## Short circuit analysis of a Doubly Fed Induction Generator and their Impact on Generator Circuit Breakers

A3 – PS1, Paper No: 10805

Figure K.1 – Equivalent circuit of a DFIM

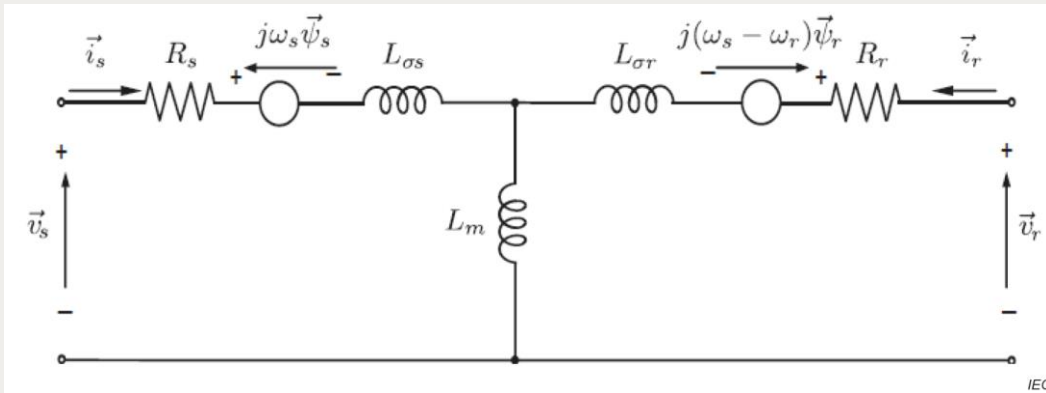
- Authors intention is not to omit this Annex in IEC/IEEE 62271-37-013. But more detailed explanation is necessary in relation the figures K.1 & K.2.
  - Mentioning of crowbar resistor is missing in K.1 and also formula of converting the crowbar resistance from rotor side to stator side while analysing short circuit behaviour on stator side. This is given in detail in paper 10805.
  - Machine details used to generate figure K.2 is missing as well. In our opinion this curve is only possible for very high crowbar resistance values (~ 100 mOhms) which is not possible in practice due to the fact that such high resistance can create a higher voltage drop across the converter which can damage it.

**Key Message: Annex K needs to be further elaborated with more details.**
